Subject: Response to Environmental Impact Statement for Horsley Drive Business Park Stage 2, Buildings 2 and 3 (SSD- 17161650)

Notice of Exhibition – Horsley Drive Business Park Stage 2 – Buildings 2 and 3 (SSD-17161650)

Re: Advice on Environmental Impact Statement (EIS) – Horsley Drive Business Park Stage 2 Buildings 2 & 3 (SSD-17161650)

Horsley Drive Business Park Stage 2 – Buildings 2 & 3 – EIS (SSD-17161650)

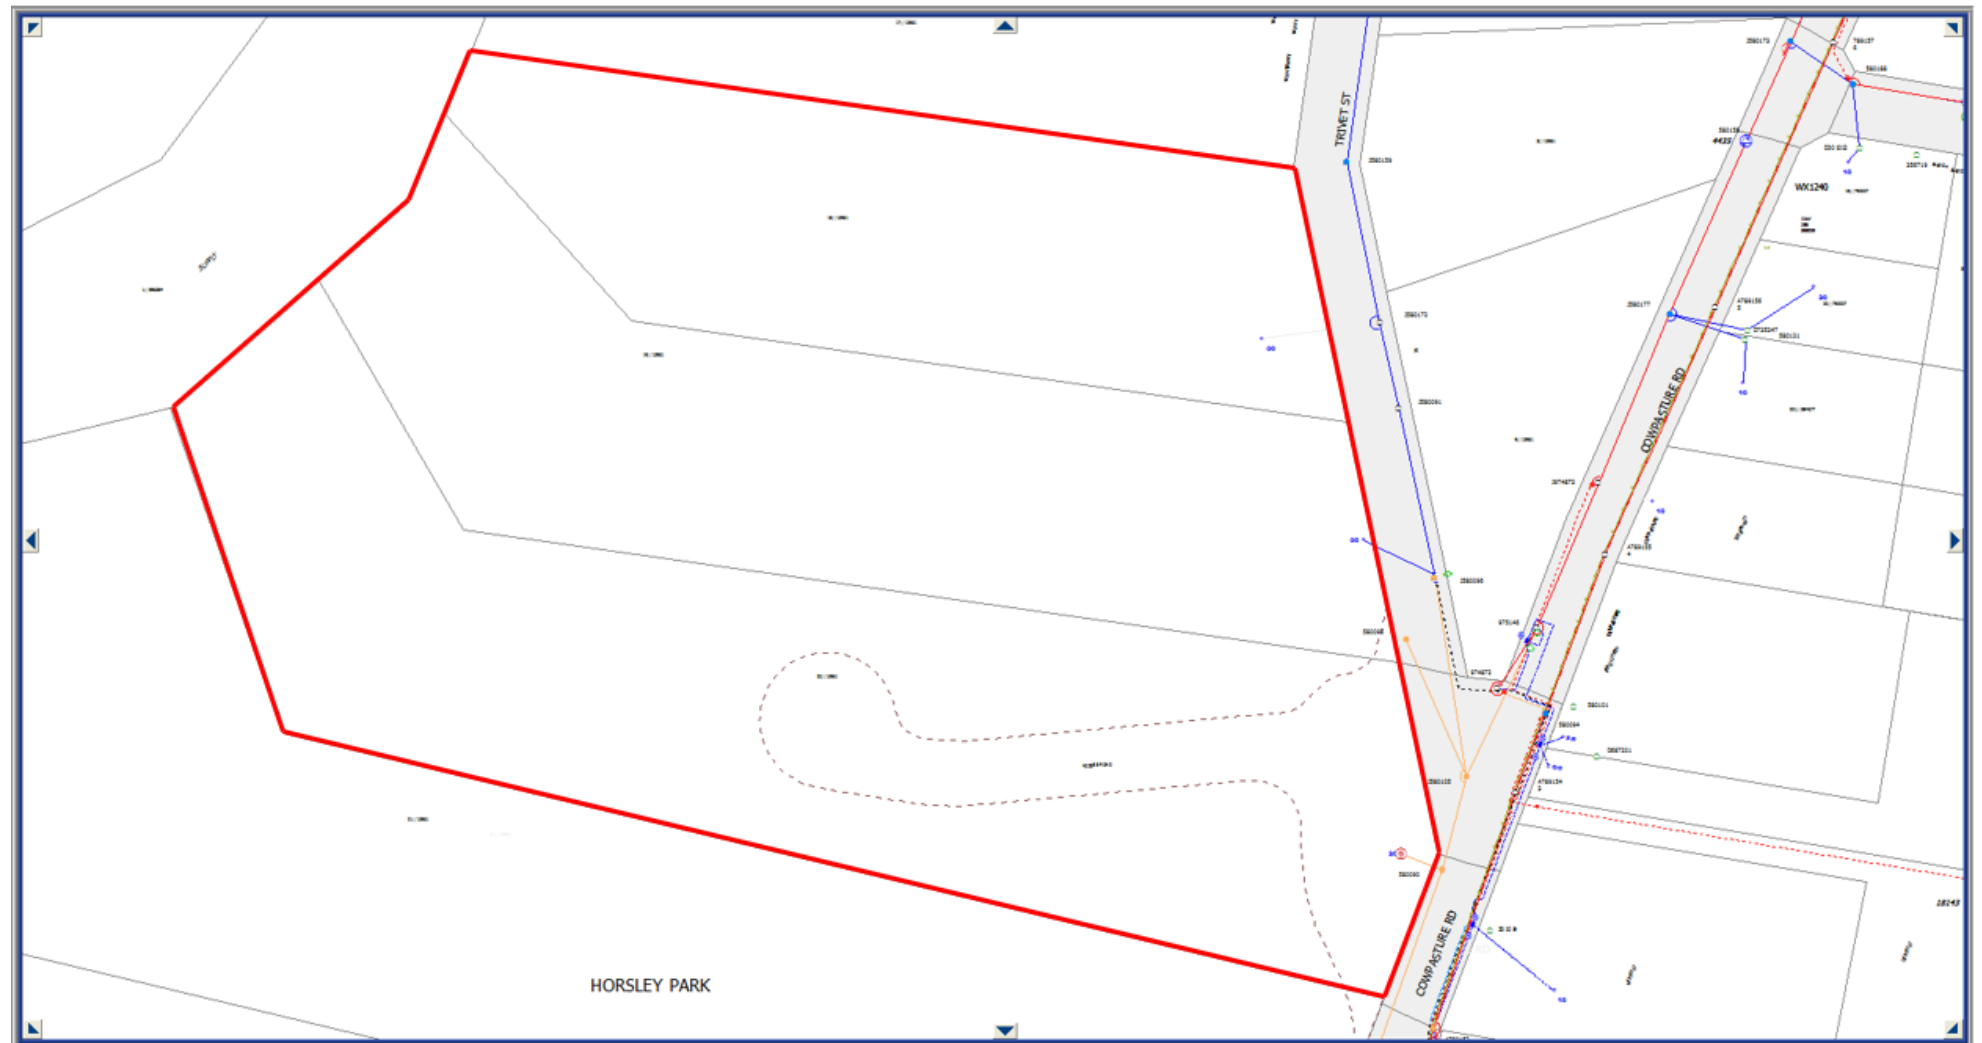
As shown in the below site plan from Endeavour Energy's G/Net master facility model:

- No easements benefitting Endeavour Energy (active easements are indicated by red hatching).
- Low voltage overhead power lines to the Cowpasture Road and parts of the Trivet Street road verges / roadways including low voltage overhead service conductors going to the customer connection points for the existing premises. The  colouring of the conductors indicates 'Proposed Removed'.
- 'Developer Area' shown by the proposed road layout indicating enquiries and applications for contestable works projects with Endeavour Energy's Customer Network Solutions Branch for electricity supply.

Site Plan from Endeavour Energy's G/Net Master Facility Model

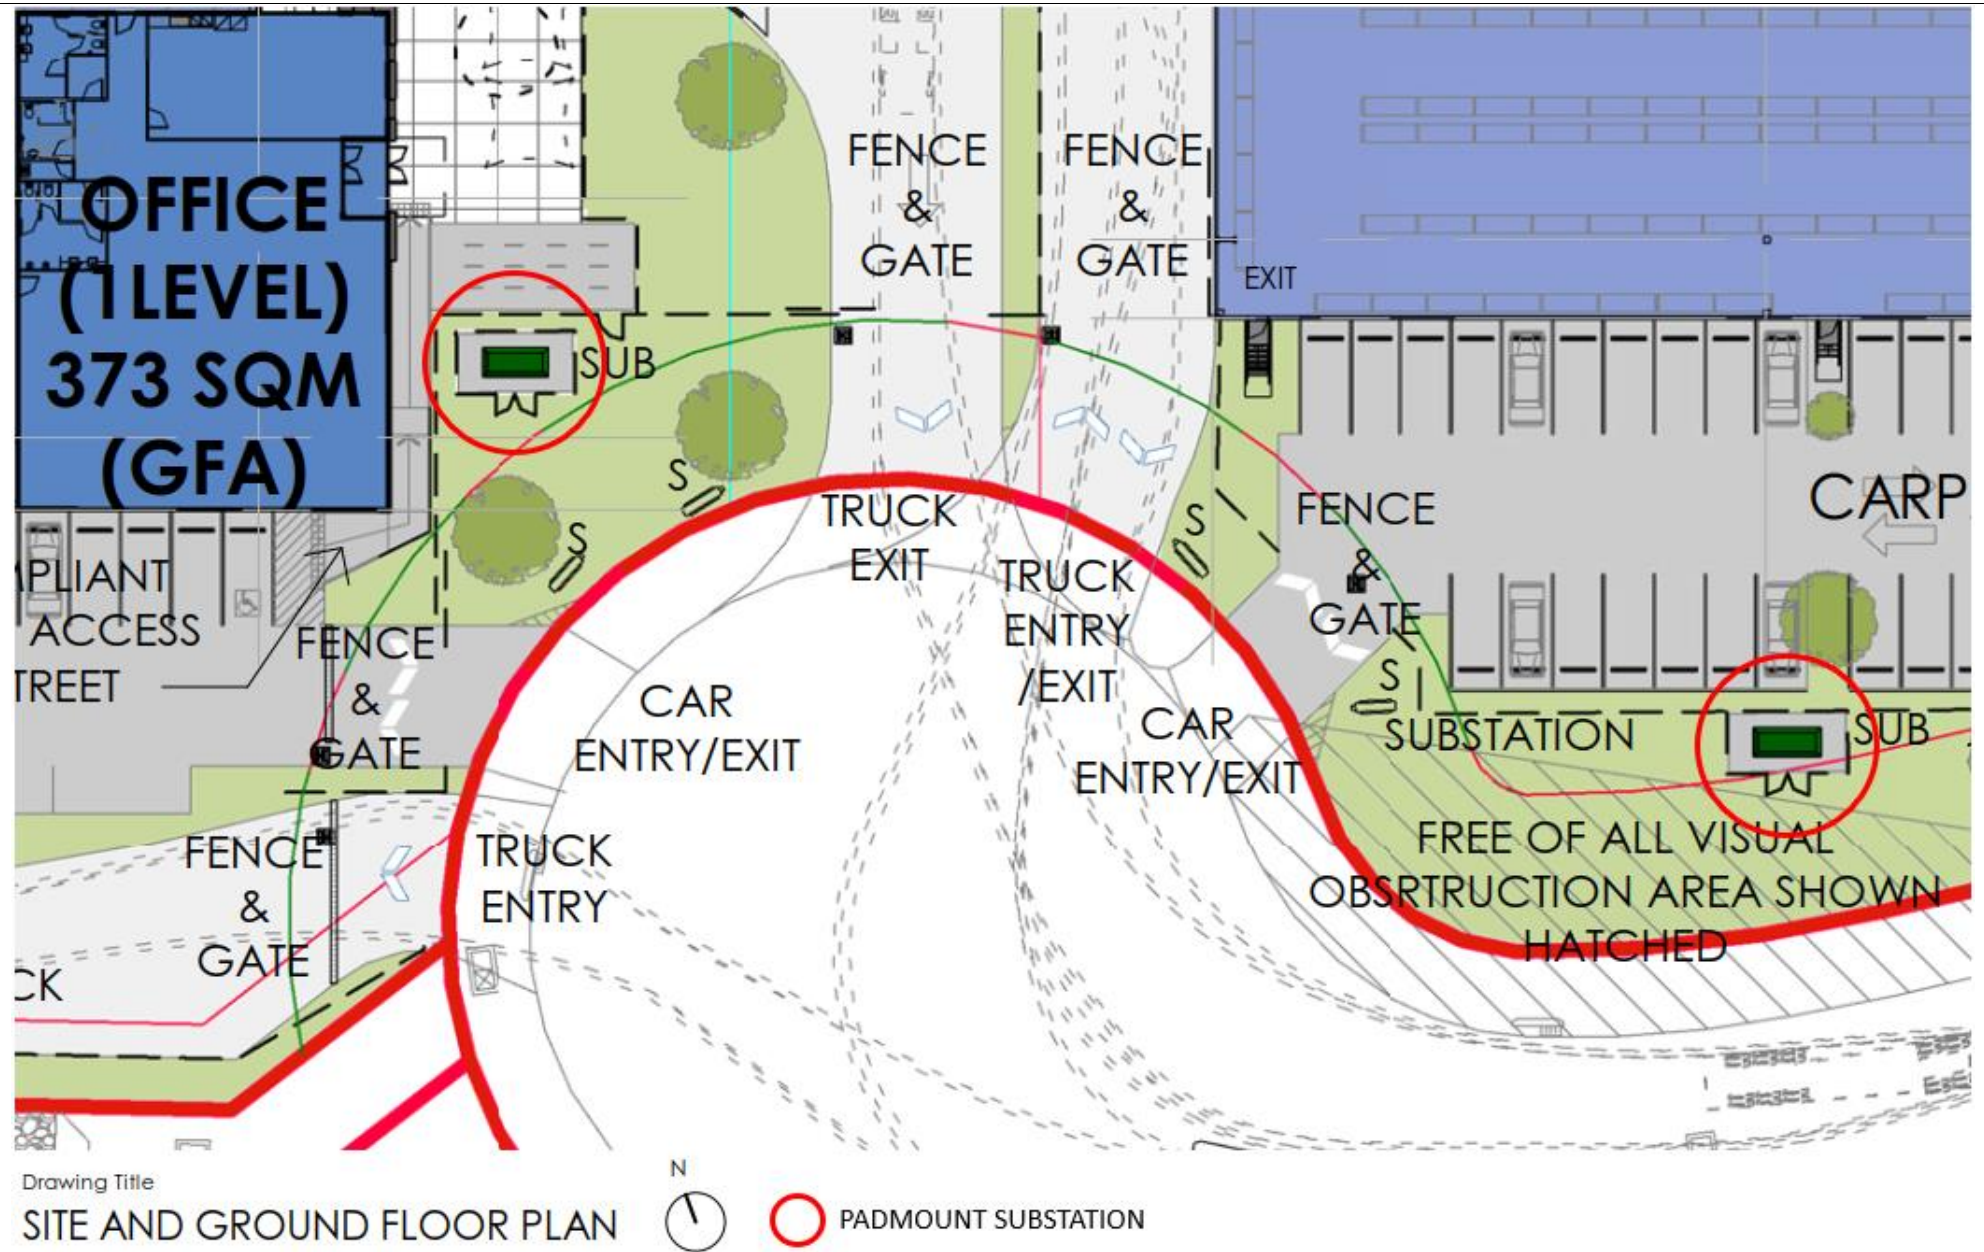
- An extension and / or augmentation of the existing local network will be required. However the extent of any works required will not be determined until the final load assessment is completed. - The Architectural Drawings Plans show the provision of two padmount substations. The padmount substation will need to be located within the property (in a suitable and accessible location) and be protected (including any associated cabling) by an easement and associated restrictions benefiting and gifted to Endeavour Energy. Please refer to Endeavour Energy's Mains Design Instruction MDI 0044 'Easements and Property Tenure Rights'. - Generally it is the Level 3 Accredited Service Provider's (ASP) responsibility (engaged by the developer) to make sure that the substation location and design complies with Endeavour Energy's standards the suitability of access, safety clearances, fire ratings, flooding etc. - Endeavour Energy is urging applicants /customers to engage with an Electrical Consultant prior to finalising plans to in order to assess and incorporate any required electricity infrastructure. In so doing the consideration can also be given to its impact on the other aspects of the proposed development. This can assist in avoiding the making of amendments to the plan or possibly the need to later seek modification of an approved development application. - Not all the conditions / advice marked may be directly or immediately relevant or significant to the Development Application. However, Endeavour Energy's preference is to alert proponents / applicants of the potential matters that may arise should development within closer proximity of the existing and/or required electricity infrastructure needed to facilitate the proposed development on or in the vicinity of the site occur.
